Architect's Supplemental Instructions

Architect's ASI No: 019

Project:
Webster University
Interdisciplinary Science
Building

Description: ASI – 019 (RFI-193,RFI-208 & RFI-212)

2 TYPICAL FIRE SERVICE ENTRANCE DETAIL

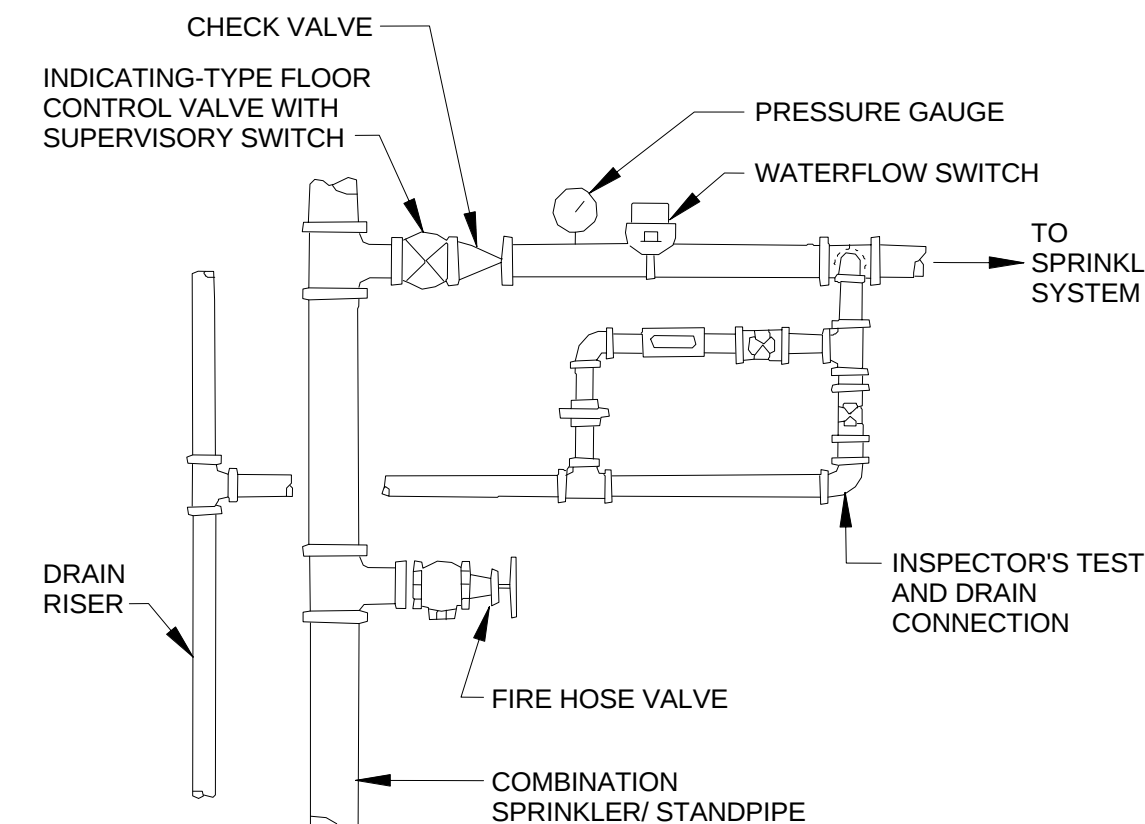
RFI-150, (FP0501); request verification that the 2-inch main drain can handle test flows. The 2-inch main drain needs to drain to exterior of the building, not to area way. The discharge is to be located and directed to allow runoff away from the building. Consideration is to be given to prevent ground erosion or damage to the surrounding area by use of concrete splash block, slab block, slab or other means. Coordination location of drain with the architect, civil engineer, landscape architect and other building trades as required. Refer to drawing FP0501, detail 7 and also see detail 2 for similar modifications.

1 LEVEL 03 AREA A FLOOR PLAN - PLUMBING
1/8" = 1'-0"

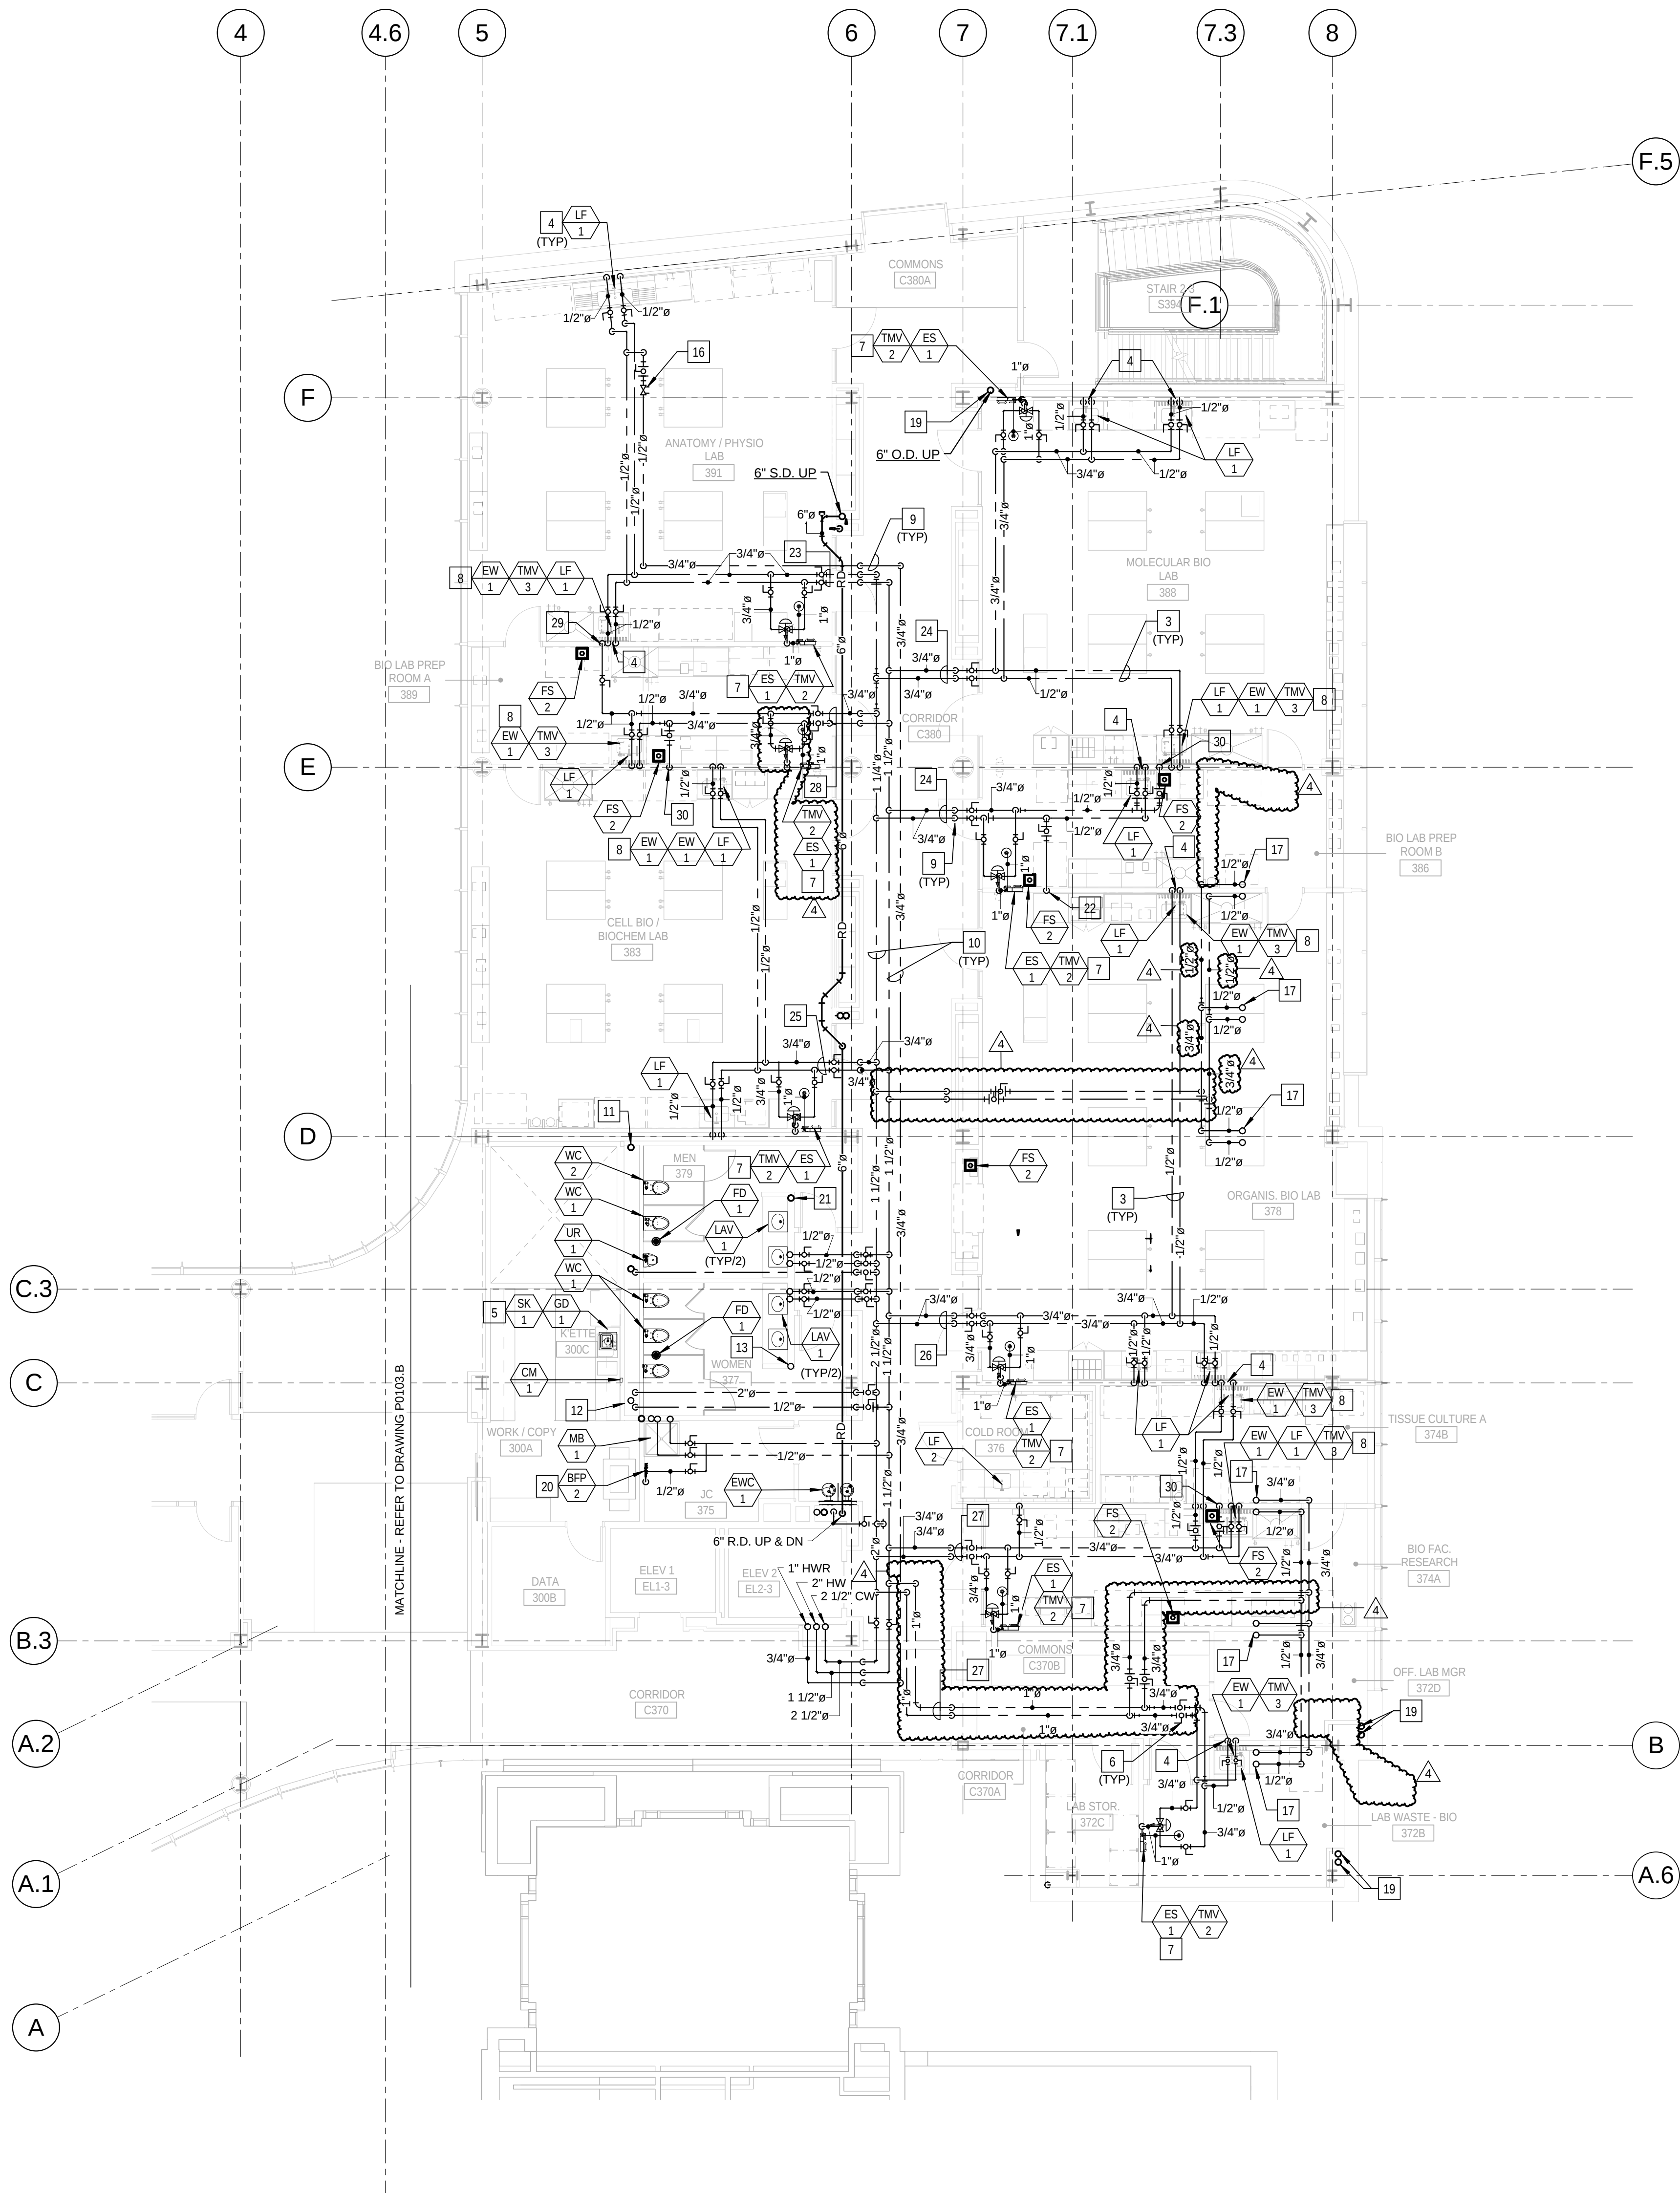
RFI-212,(P0103.A); request clarification on the installation of an emergency fixture located in Room 389 Bio Lab Prep Room A. There is an emergency shower is located in Room 389 and the piping and fixture tags were inadvertently left out, however the shower was shown on drawing P0405 Riser Plumbing. Refer to drawing P0103.A for all associated modifications.

1 LEVEL 04 AREA A FLOOR PLAN - PLUMBING
1/8" = 1'-0"

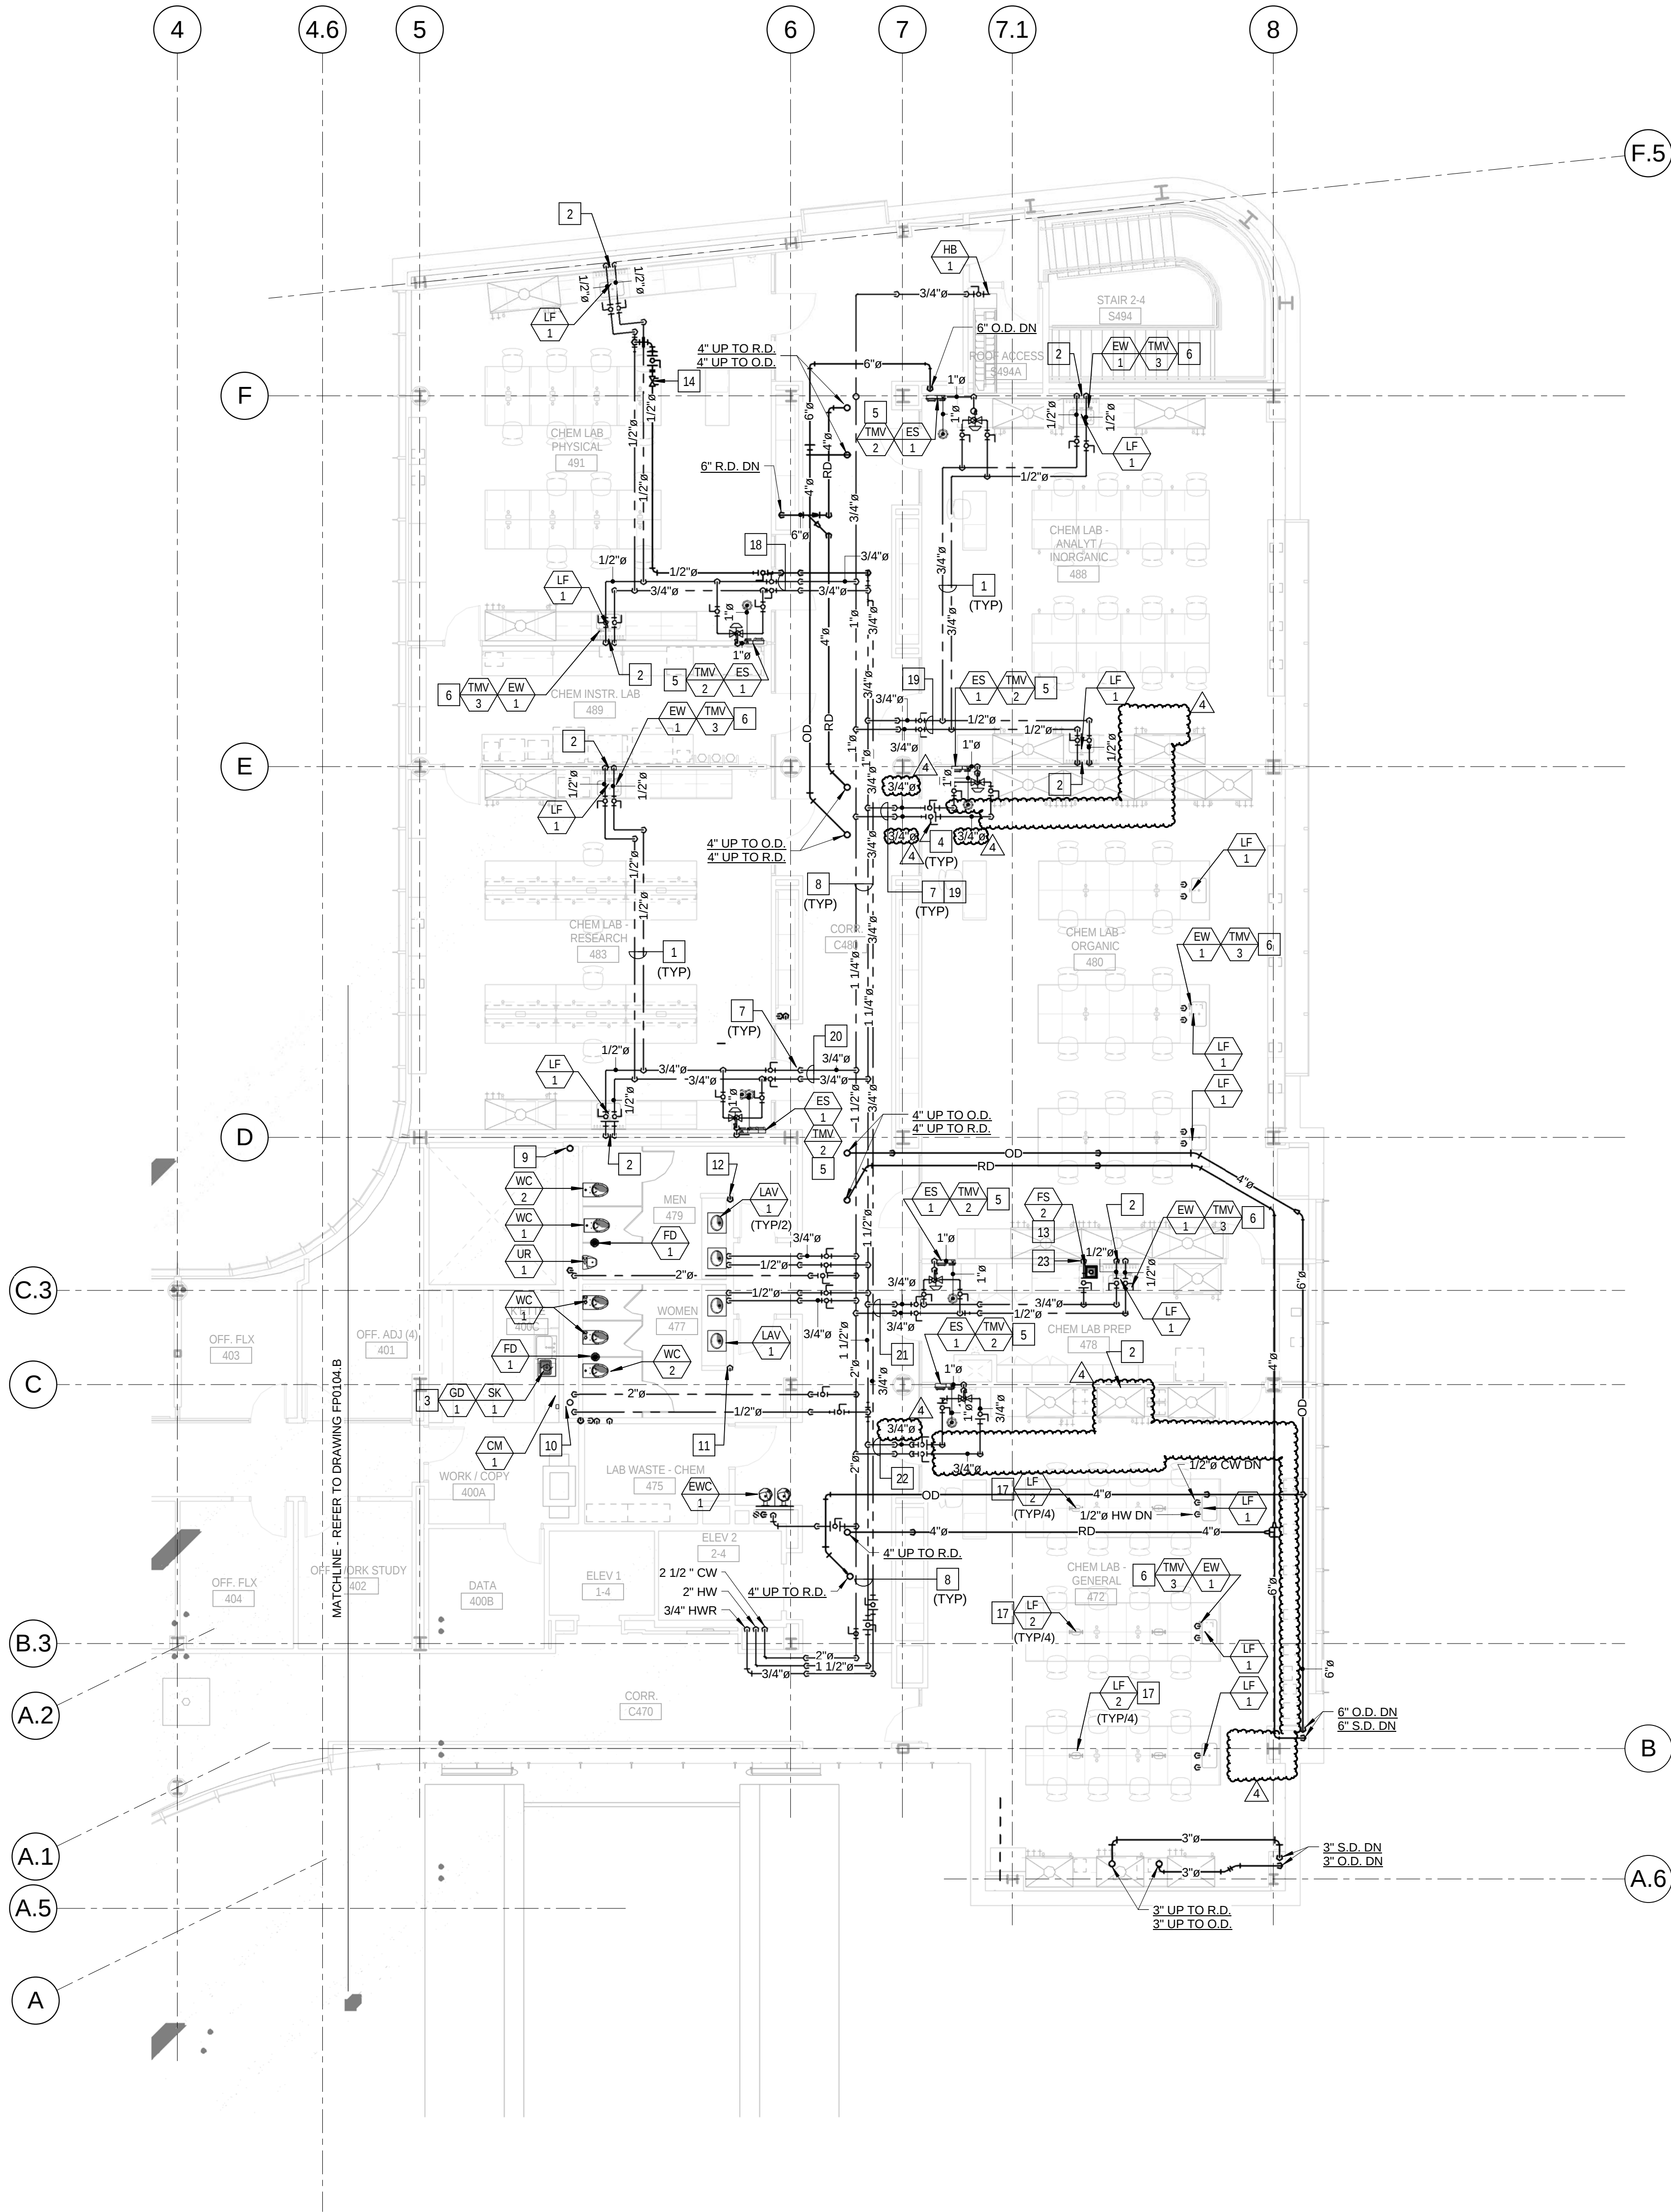
RFI-208,(P0103.A/P0407/P0409); request that attention be bought to the issue of length of the hot water run serving the island sink in Room 472 Chem Lab-General and Room 480 Chem Lab-Organic. The run of non-recirculated dead-end piping from the main to the sink would result in a long wait for hot water. As result water supplier to sinks were removed from the 4th Floor Level and moved to the 3rd Floor Level. In Room 478, some alignments were shorten, reducing the amount of 1-inch diameter piping by approximately 84 linear feet and in Room 472, alignments were shorten reducing amount of 1-inch diameter by 54 linear feet. Other pipe sizes were modified as well. Refer to drawing P0104.A and drawing P0409 for all associated modifications.
